SUBJECT: STAFF RESPONSE TO WILLIAM H. WARD'S LETTER ON
SEISMIC ISSUES AT WOLF CREEK

STAFF RESPONSE TO WILLIAM H. WARD'S LETTER ON
SEISMIC ISSUES AT WOLF CREEK

SUBJECT: SITE SPECIFIC GROUND RESPONSE SPECTRA FOR SEP PLANTS
LOCATED IN THE EASTERN UNITED STATES

Figure 14. Results of SPT Empirical Study for SSE = 0.12 G

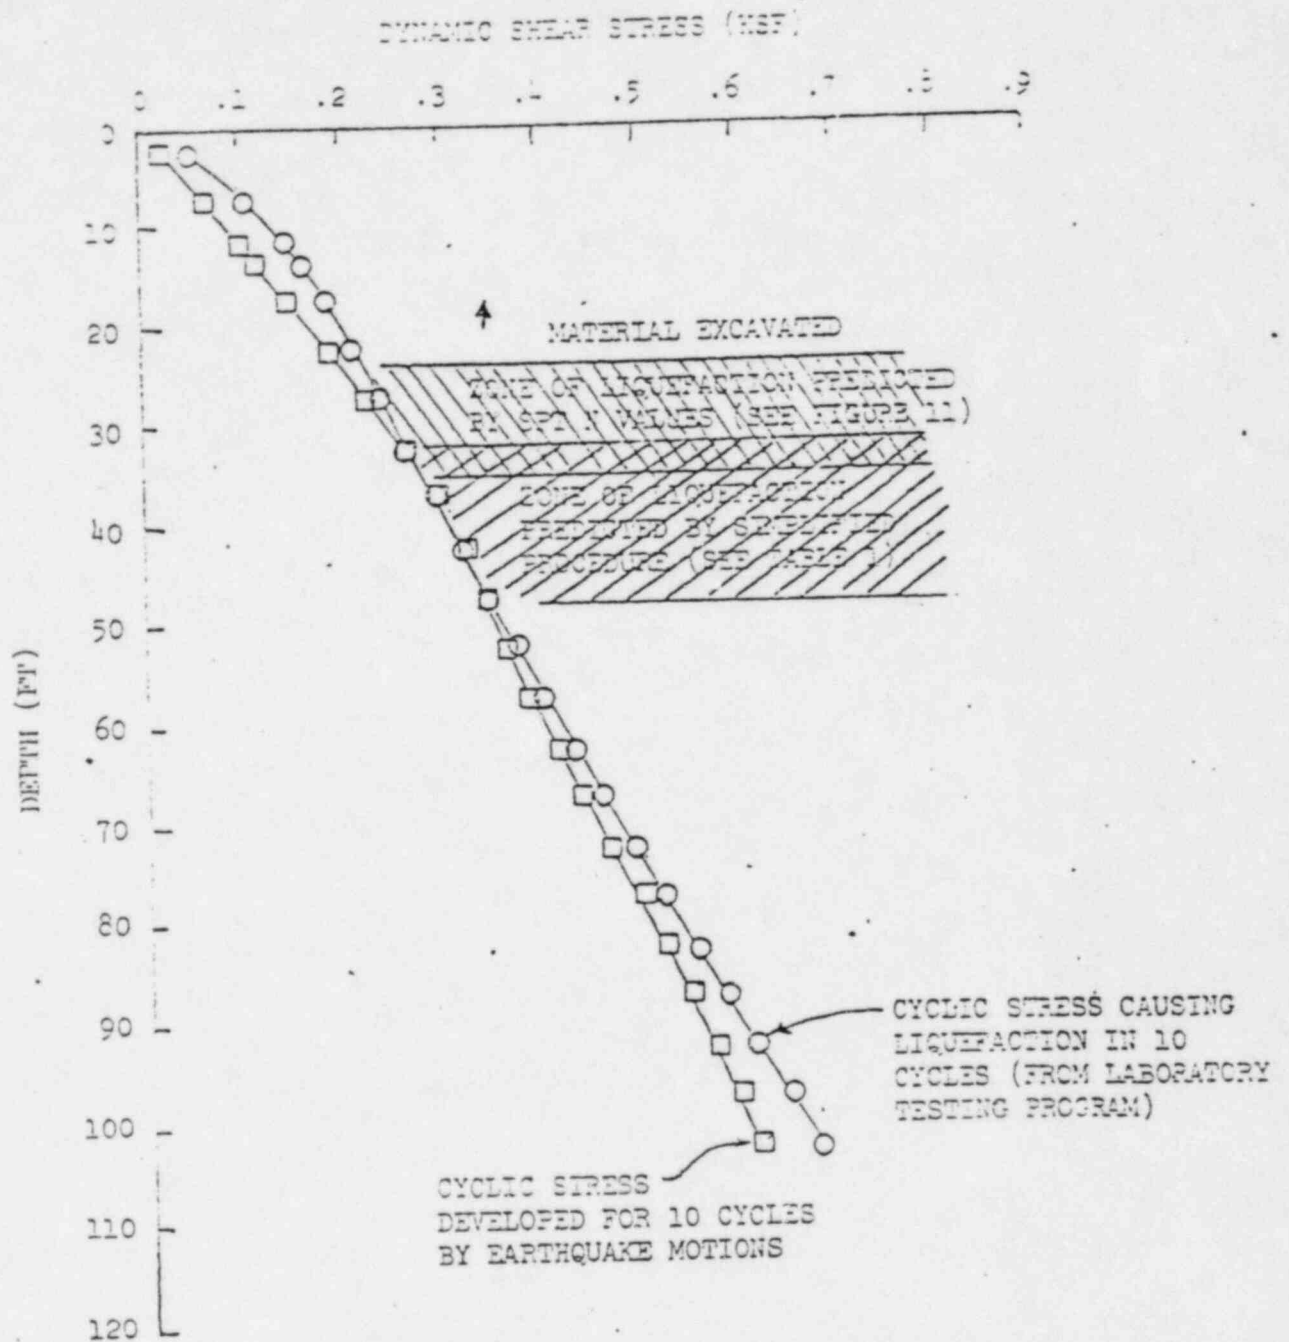
26. The liquefaction potential of the LaCross Site was evaluated for two earthquakes; namely, a SSE with a peak acceleration at the ground surface of 0.12 g, and a SSE with a peak acceleration at the ground surface of 0.2 g. The analysis was made by two methods; namely, the Seed-Idriss Simplified Procedure and an empirical procedure. Figure 14 is a summary plot of the dynamic shear stress as a function of depth for a peak acceleration of 0.12 g. Superimposed on this plot is a cyclic strength of the material assuming 10 equivalent cycles of loading. Note that liquefaction is predicted by the Seed-Idriss calculations between a depth of 32 and 48 ft and liquefaction is predicted by the empirical methods based on a depth of between 24 and 35 ft. Japanese experience at Niigata, Japan, also indicates that liquefaction would be predicted with a depth of 15 ft. As indicated in Appendix A, the piles could

Figure 15. Results of SPT Empirical Study for $SSR = 0.20 G$

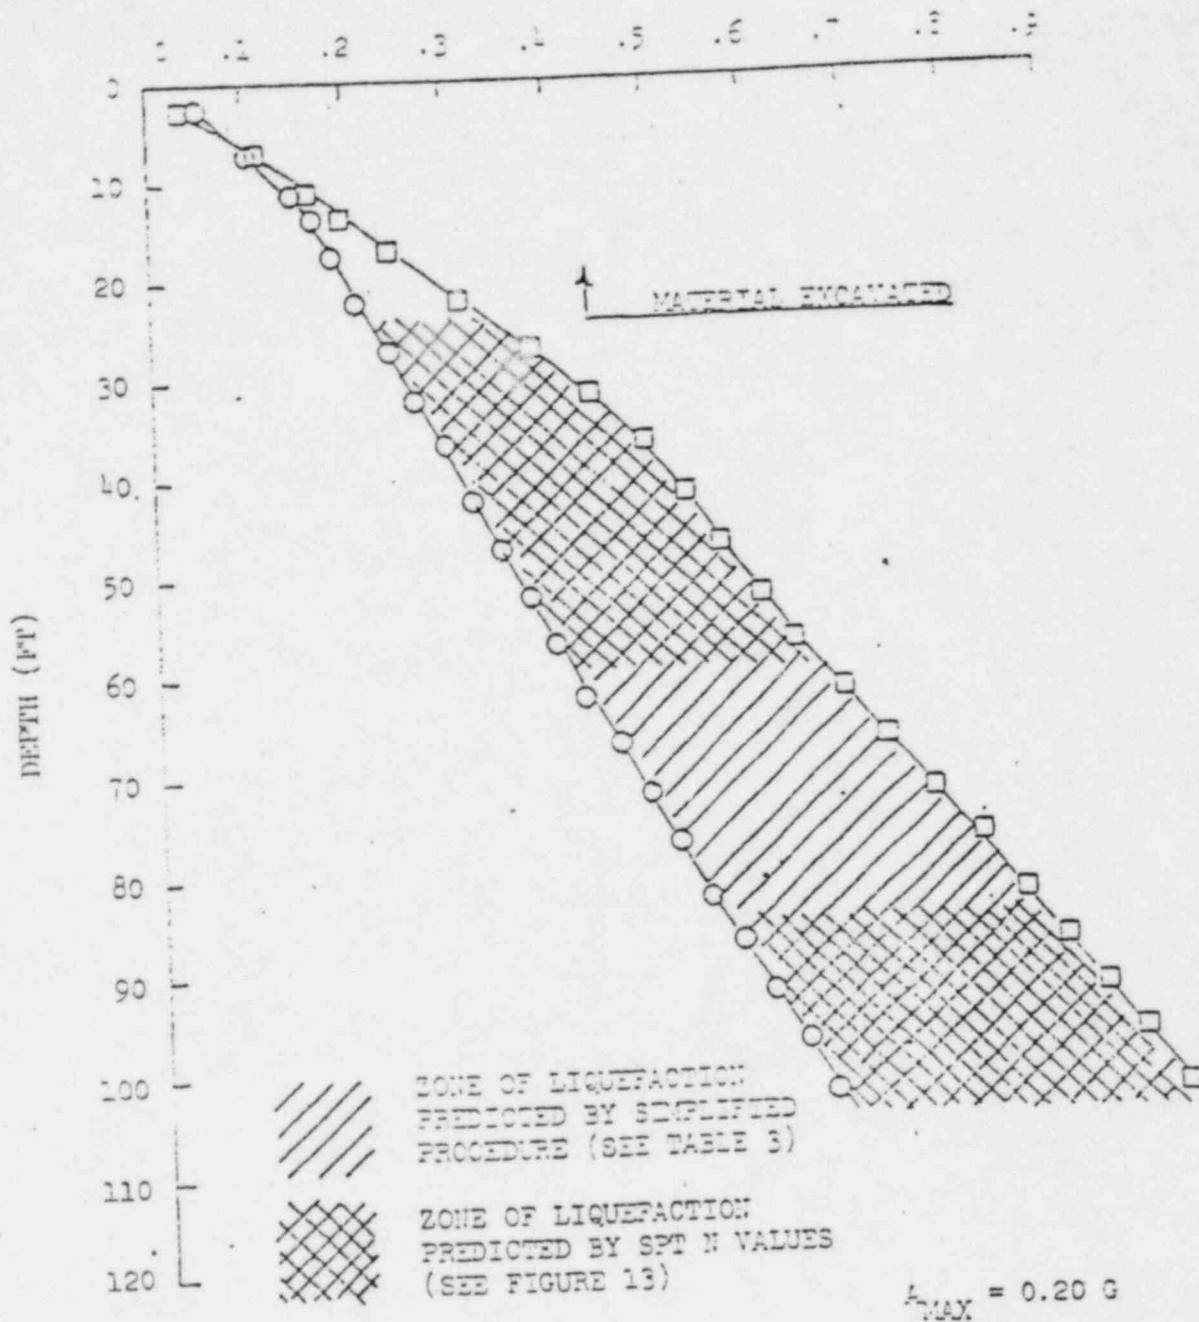
27. Figure 15 is a summary plot of the dynamic shear stress as a function of depth for the soil profile assuming a peak acceleration of 0.2 g. Also shown on this plot is the dynamic shear strength of the soil assuming 10 equivalent cycles of loading. The Seed-Idriss Simplified Procedure predicts liquefaction below a depth of 25 ft. The empirical method predicts liquefaction between a depth of 25 and 60 ft and between a depth of 85 and 105 ft. If lateral support is lost in the depth ranges predicted by either method, the piles would be in danger of buckling failures as indicated in Appendix A.

For the 0.2 g loading there is no point in performing such an analysis as Figure 15 of the main text indicates a possible unsupported length of over 80 ft. If loss of lateral support should occur over this length, as shown on Figure A1, the pile would buckle under its static load alone.
